UNITED STATES PATENT AND TRADEMARK OFFICE

| APPLICATION NO. | FILING DATE | FIRST NAMED INVENTOR | ATTORNEY DOCKET NO. | CONFIRMATION NO. |
|---|-------------|----------------------|---------------------|------------------|
| 10/730,834 | 12/08/2003 | Nick Kuo | JCLA11759 | 5204 |

Office Action Summary

DETAILED ACTION

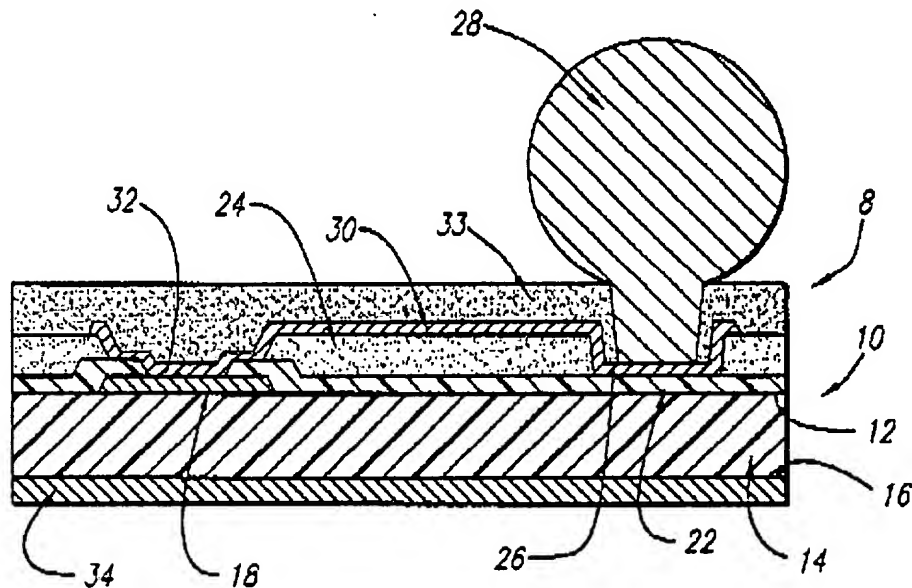
2. Applicant's election without traverse of species 4 (figs. 1d and 2d) in the reply filed on 9/07/2005 is acknowledged. Amended claims 23-24, 35, 37 and 46-50 were withdrawn from consideration because they are not supported by the elected species. Note that in figure 2 does not show "a third portion" (emphasis added). Note that the elected species includes only two portions one for a solder bump connection and a second one for testing or wire bonding.

FIG.3

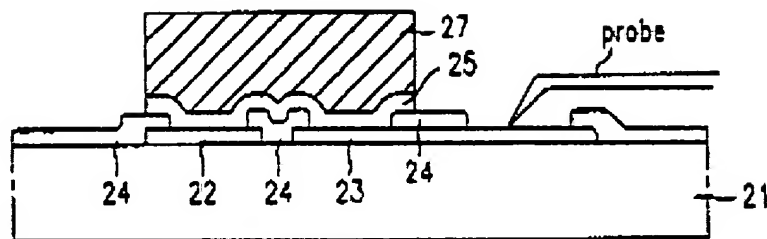
Elenius does not teach a testing pad or second portion used to be tested thereto. Nevertheless, Kim (e.g. fig. 3) shows a testing pad 23 electrically connected to a bump pad 22. This type of embodiment prevent decreases in testing reliability caused by damages on the surface of the bump and polluting material thereby enhancing its yield with respect to bonding (col. 2/ls. 10-30).

It would have been obvious to one of ordinary skill in the art at the time the invention was made to include a second portion used to be tested thereto or include a test pad electrically in order to prevent decreases in testing reliability caused by damages on the surface of the bump and polluting material during the testing process, thereby enhancing its yield with respect to bonding as taught by Kim.

FIG. 2I

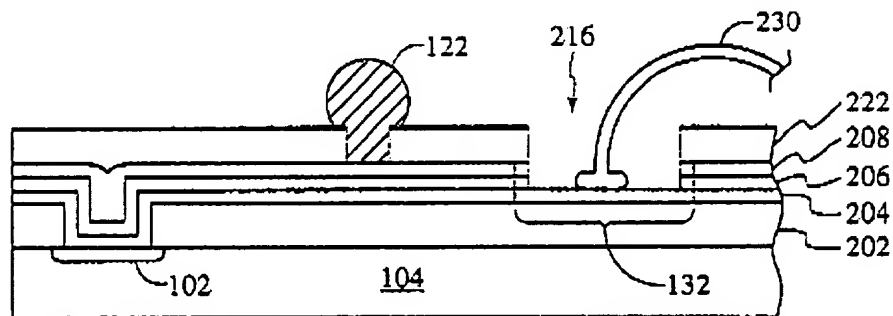
24. Regarding claim 27, Lam (e.g. fig. 2A-2I) shows a semiconductor substrate 104; a bond pad 102 structure over the semiconductor substrate; a passivation layer 202 exposes a top surface of the metallization structure; a patterned circuit layer 204-208 connected to the top surface, wherein the patterned circuit layer comprises a first portion 214 having a bump 122 formed thereover and a second portion 216 used to be wirebonded thereto (col. 1/23-33 & co. 2/lls. 30-51).

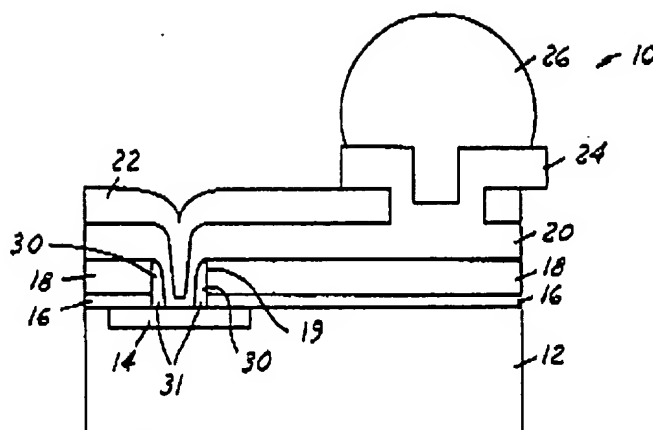
Lam does not explicitly disclose that the bond pad structure 102 is a metallization structure. Nevertheless, Liao (e.g. fig. 3) shows an analogous circuitry including a bond pad 14, which is a metallization structure.

It would have been obvious to one of ordinary skill in the art at the time the invention was made to make bond pad disclosed by Lam of metal as suggested by Liao to provide a bond pad having low electrical resistant and good thermal conduction, and because it has been held to be within the general skill of a worker in the art to select a known material on the basis of its suitability for the intended use as a matter of obvious design choice. In re Leshin, 125 USPQ 416.
